**METROPOLITAN GOVERNMENT OF NASHVILLE AND DAVIDSON COUNTY**

**STAFF RECOMMENDATION**  
**1404 Linden Avenue**  
**December 21, 2016**

**Application:** Demolition; New construction – infill and outbuilding  
**District:** Belmont-Hillsboro Neighborhood Conservation Zoning Overlay  
**Council District:** 18  
**Map and Parcel Number:** 10513007700  
**Applicant:** Preston Quirk, Architect  
**Project Lead:** Sean Alexander, sean.alexander@nashville.gov

**Description of Project:** The applicant proposes to demolish the existing building and construct a new single-family house. The house will be one and one-half stories and will have a cross-gabled roof. A detached outbuilding will also be built at the rear of the lot.

SITE PLAN

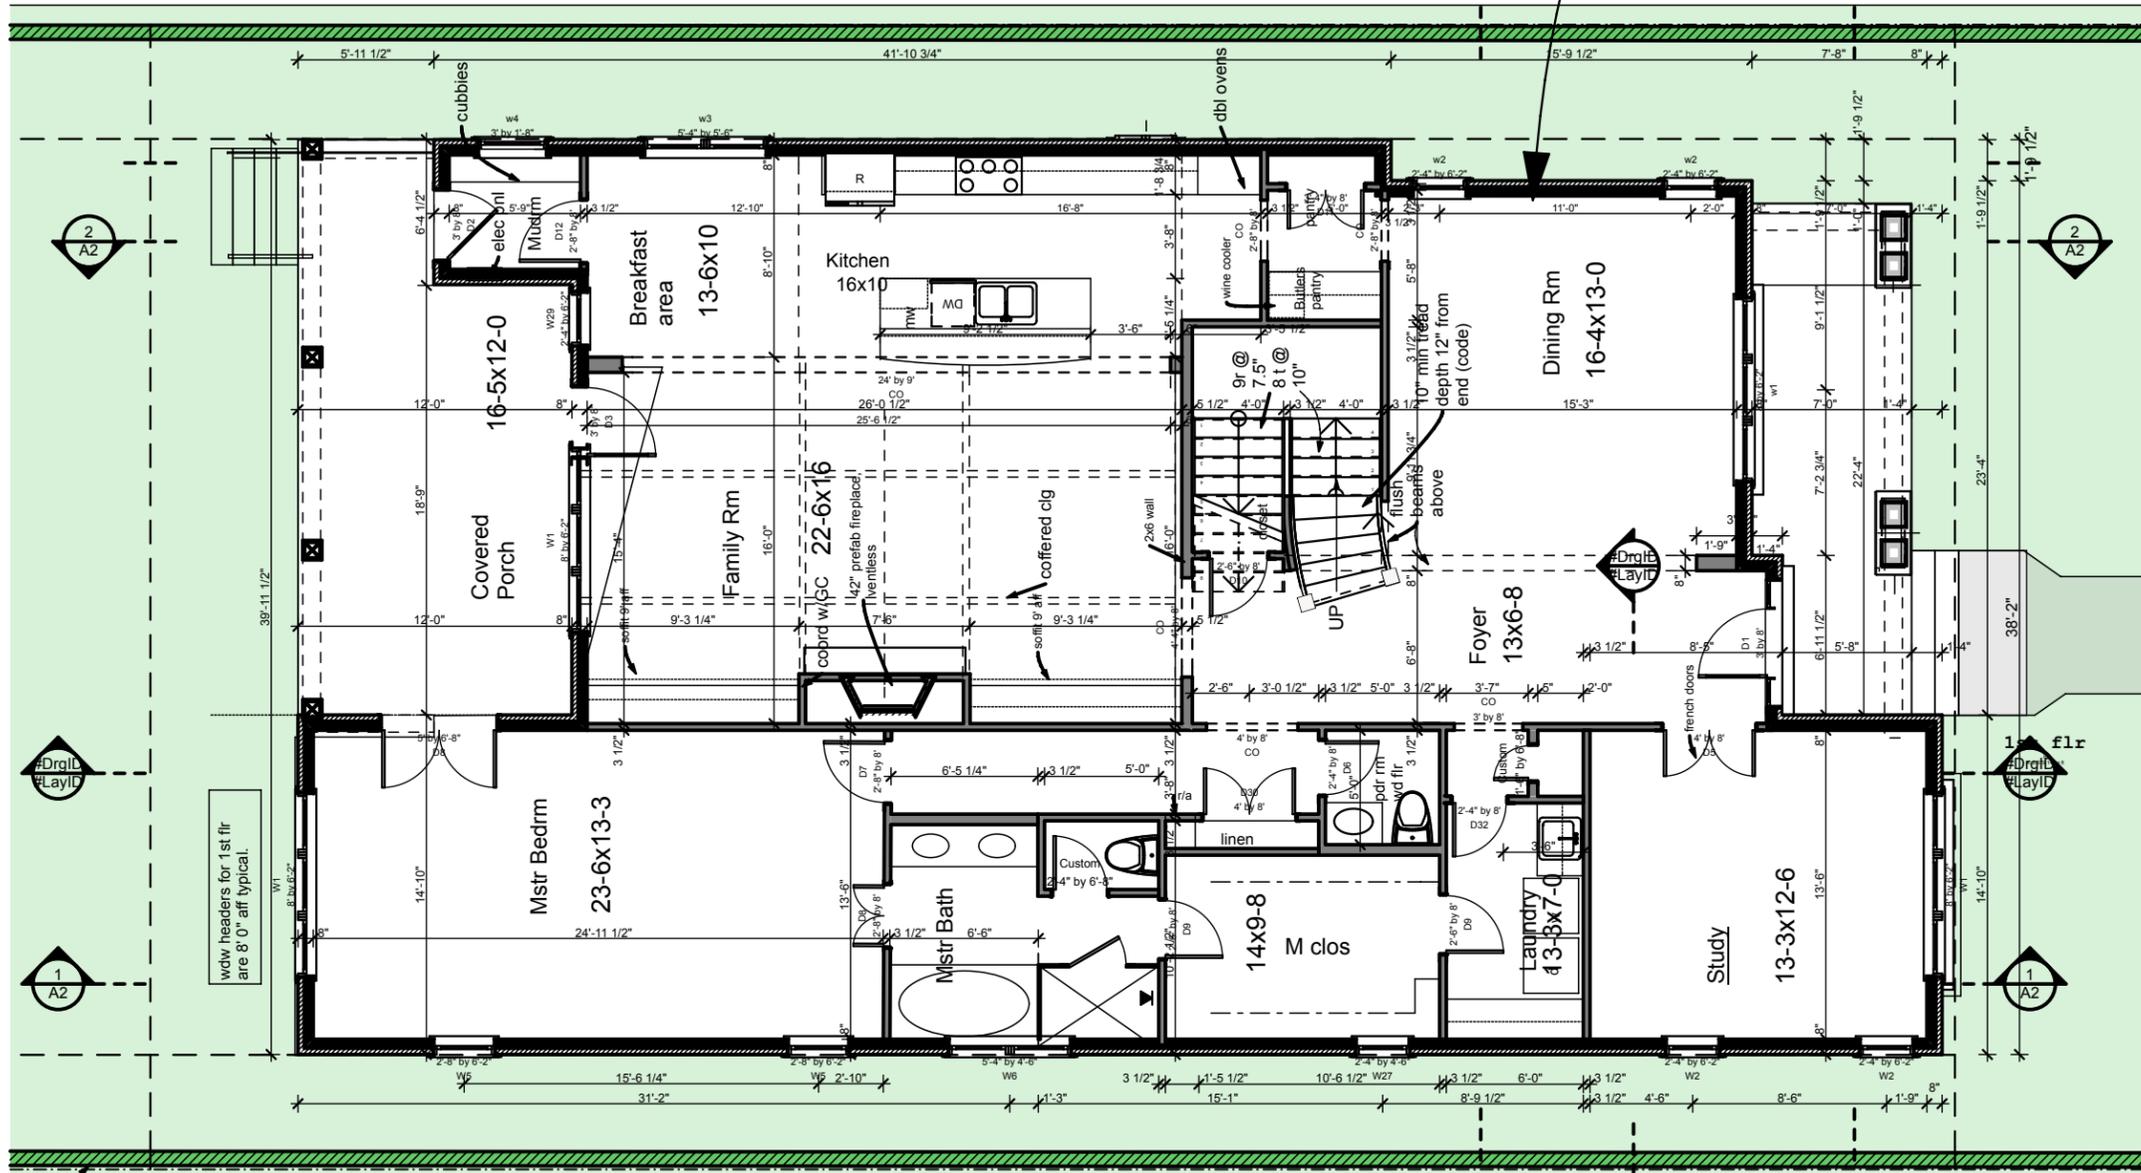
However, the plans show the lot as being flat where in actuality it slopes approximately two feet (2') down left-to-right and twelve feet (12') down from back-to-front. As a result the exposed foundation could end up several feet taller in construction, which would ultimately make the overall height of the building taller as well. Staff recommends that drawings accurately showing the grade are submitted prior to permitting, to verify that the foundation height is consistent with the context, and that the foundation is inspected on site to verify that the floor level is in line with the adjacent houses. If the building is taller than thirty-three feet (33'), as measured at the front grade, staff will bring the case back to the Commission.

1. The overall height of the building shall be reduced by one foot (1');
2. Drawings accurately showing the grade and are submitted prior to permitting to verify that the foundation height is consistent with the context, and if those drawings show that the building is taller than thirty-three feet (33'), as measured at the front grade, staff will bring the case back to the Commission;

GARAGE PLANS

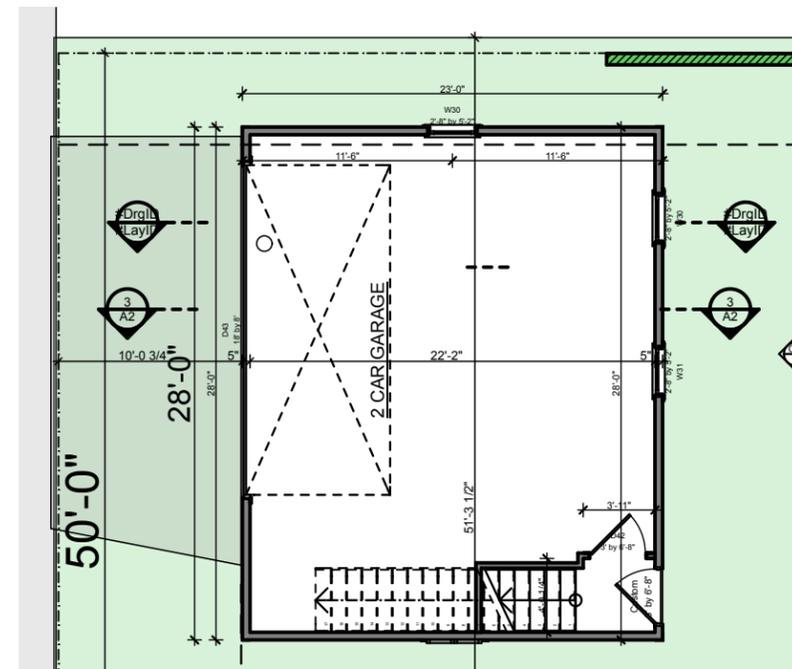
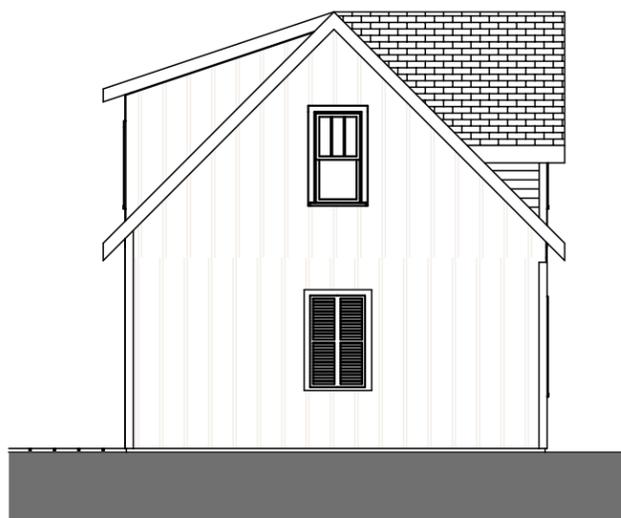
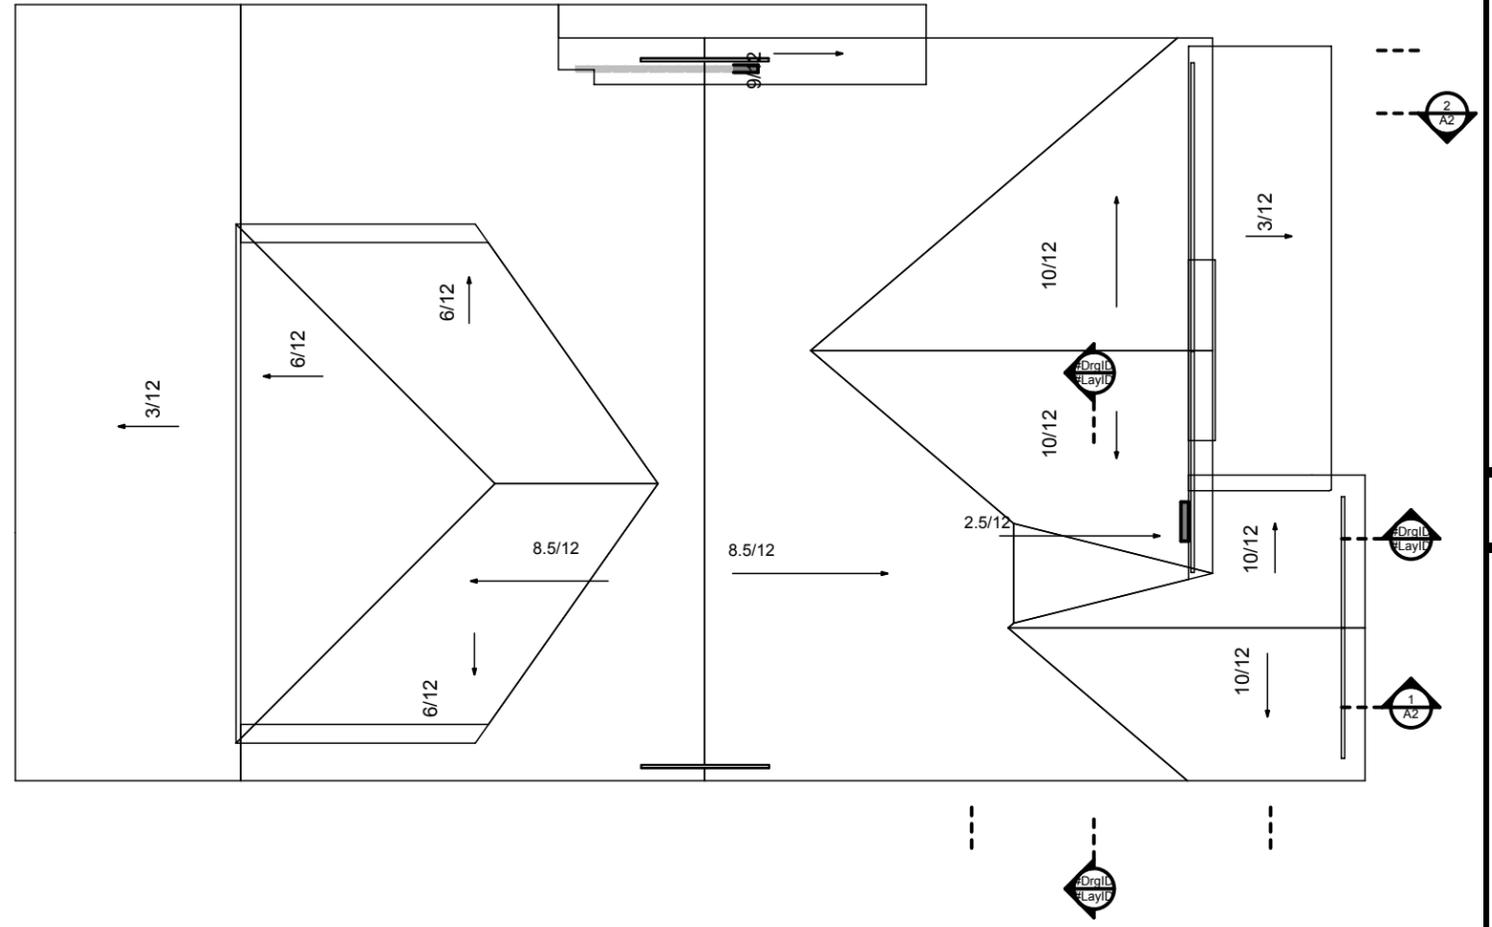
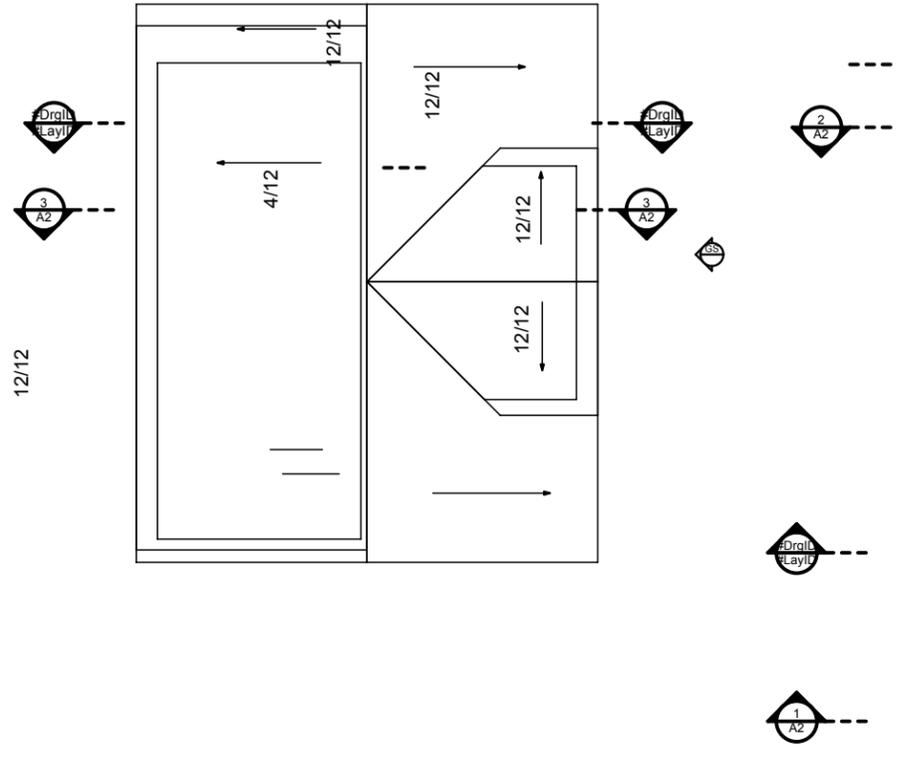
**Outbuildings:** The plan proposes a two-car detached garage with a partial upperstory at the rear of the lot. The outbuilding will be accessed via the alley, and will have a footprint of six hundred and forty-four square feet (644 sq. ft.) The building will have a side-gable roof, with a gabled dormer on the front and a shed-roofed dormer on the rear. Both dormers would be wall dormers, with walls stacked directly over the first story walls below. Staff recommends that the front wall of the gable dormer and the side walls of the shed dormer step two feet (2') back as is typically required. The alley-facing wall of the rear dormer will not be visible from the street, therefore it would not need to step back.

The proposed materials would match those of the principal building, including cement-fiberboard board and batten siding, an asphalt shingle roof and a concrete slab foundation. The window and door materials are not indicated. The outbuilding will not be used as a Detached Accessory Dwelling Unit. With a condition that the final selection of windows and doors, including vehicle door, are approved prior to construction, Staff finds that the proposed outbuilding would meet section II.B.1.i of the design guidelines.

6. The front wall of the gable dormer and the side walls of the shed dormer on the outbuilding shall step two feet (2') from the walls below; and
7. The windows and doors on the outbuilding, including vehicle door, are approved prior to permitting.
